Open Floor Meeting 1

Impact on businesses, including tourism

GREAT representing the villagers

Sensitive Receptors
Figure 14.4

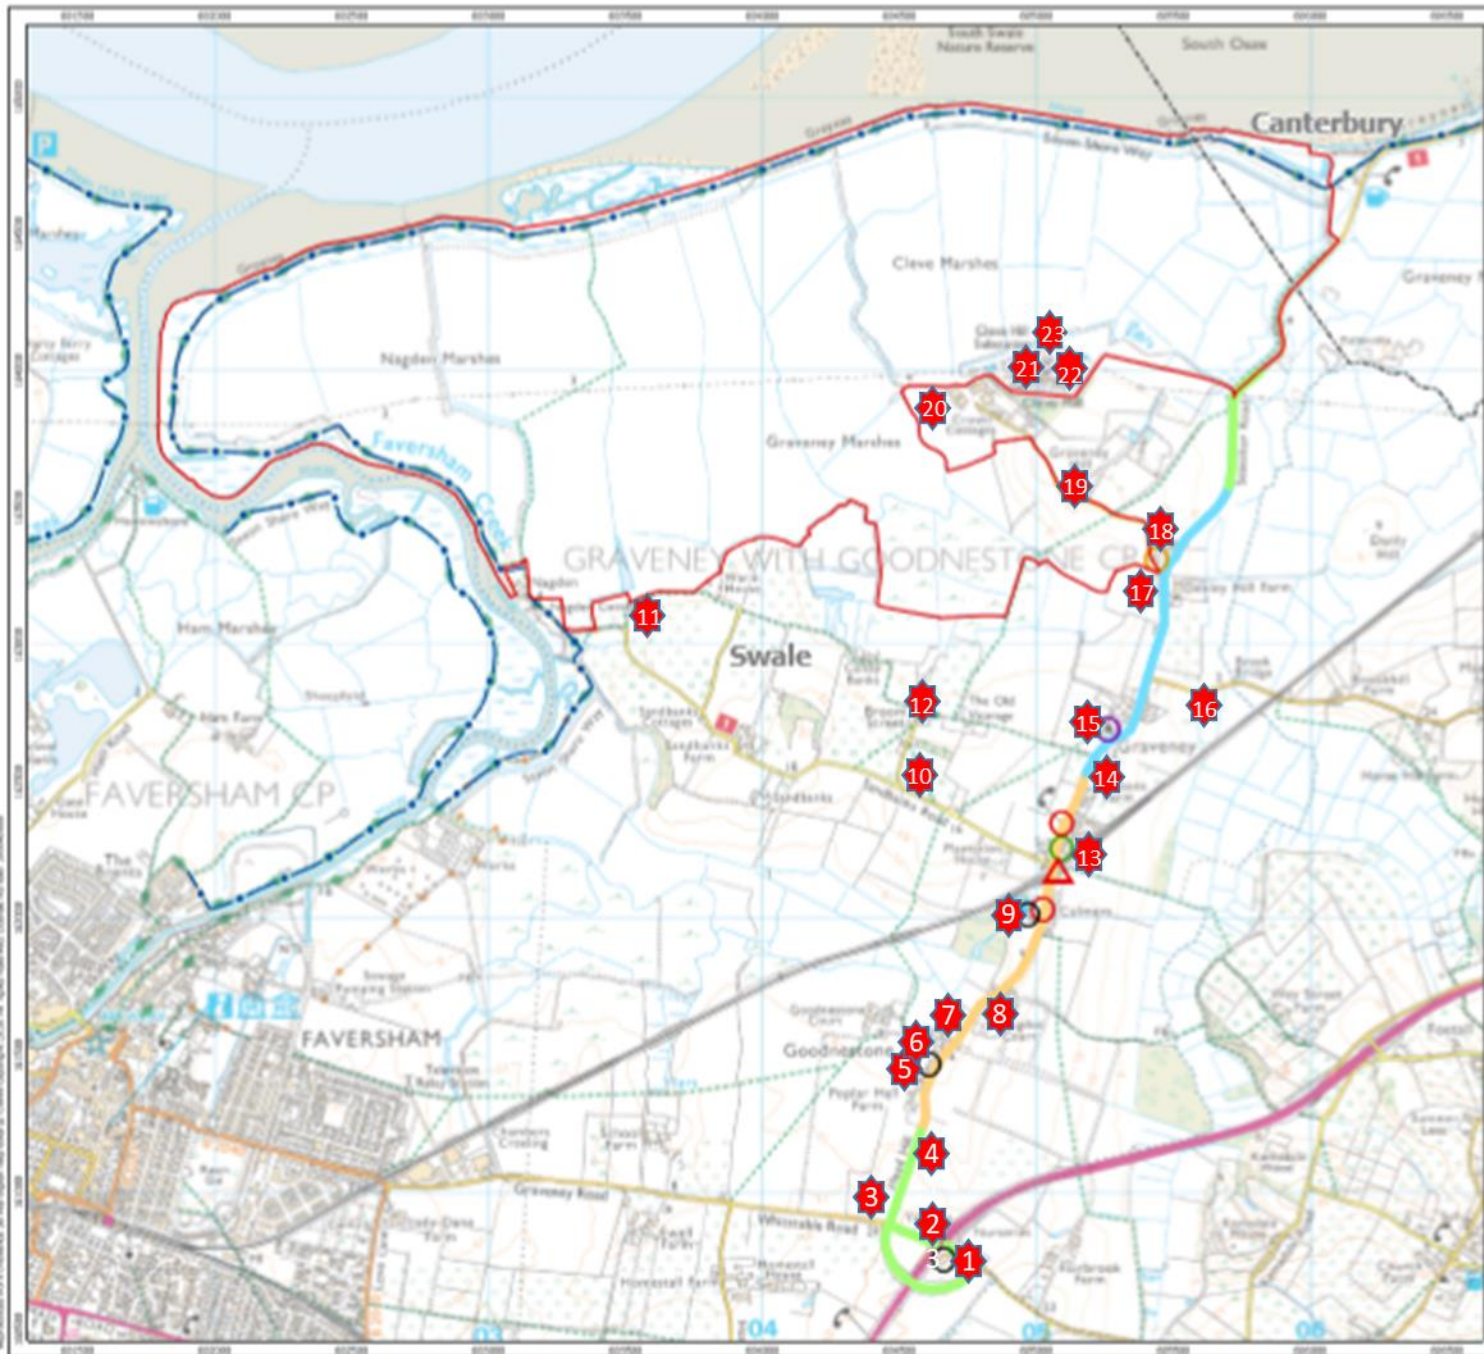
The primary route for traffic is from the top of Head Hill Road to the London Array substation access road - a distance of some 2 miles. The 'Sensitive Receptor' map produced by the applicants (Environment Statement Volume 2, Figures – Access and Traffic) identified just 6 receptors impacted by the development. Along this short distance there are actually 23 quite diverse local businesses that use this route (see map). They include a number of farms, a removal firm, a transport services company, the village school, two further educational care facilities, an equine centre, a holiday park, the Church, the village hall, London Array, National Grid and a skip company. All of these rely on good and unhindered access.

What has not been included on the applicants Sensitive Receptors map are the businesses beyond the London Array entrance which also use Headhill Road and Seasalter Road. This includes the Michelin star Sportsman restaurant, the Seasalter Chalet owners, Seasalter sailing club, Waldens shop, Forget Me Not café, Waldens caravan park, Alberta holiday park and the Oyster Pearl pub. Due to the low bridge in Seasalter all large vehicles bound for these businesses have to come through Graveney, including caravans being transported to and from the caravan parks.

The inaccuracy of the Sensitive Receptors map also includes a public telephone in the village that no longer exists. If the traffic

management plan is based on the applicant's incomplete and inaccurate information then the villagers should be given an explanation on who submitted this information, how it was obtained, and why it is so incomplete.
